Item No.	CAA Comment (Doc 0)	New Y/N	BHAL Response	Evidence Reference	Mitigation	CAA Comment on Response
5	It was noted that the issues that could not be identified prior to the CAA's IFP regulator's assessment included, but were not limited to, interactions with adjacent ANSPs, obstacle clearance, or infringement of controlled airspace (CAS) by the 'protection areas' of the IAP design.	N	There are no issues with obstacle clearance. If this observation refers to VSS penetrations, then see response in 18g. Additionally, the first design submission to the CAA (V1.0) was in May 2017. Feedback was provided to this design. Therefore, the CAA have always been aware that there have been overlaps between Gatwick CTA and the procedure Primary Protection Areas (which has changed very little since the V1 submission). To suggest this was not identified prior to the CAAs IFP assessment is not correct, as it was discussed extensively during the project.	Minutes of meetings with the CAA. Design document submissions Doc 1 : Response to CAA clarifying questions Jan 2018 ftp://rms.ftp@37.1.99.153/Doc 1 - Response to CAA clarifying Questions 31 Jan 2018.pdf Doc 2 : Informal Pre Framework Briefing Mee

Doc 19 : Grant County

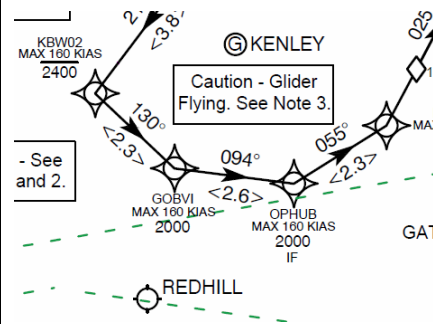
Examples of Approved RNAV Approaches with Non- Standard Approaches and Non-Standard leg lengths.

The examples shown are noted. The establishment of any GNSS IAP is assessed on its own merits. The example of Madeira has longer RF legs with a 4.7nm IF segment following a 5.7nm FAS. In addition, IAPs in Europe are wholly contained within controlled airspace (CAS) where the pilots will not be subjected to the various
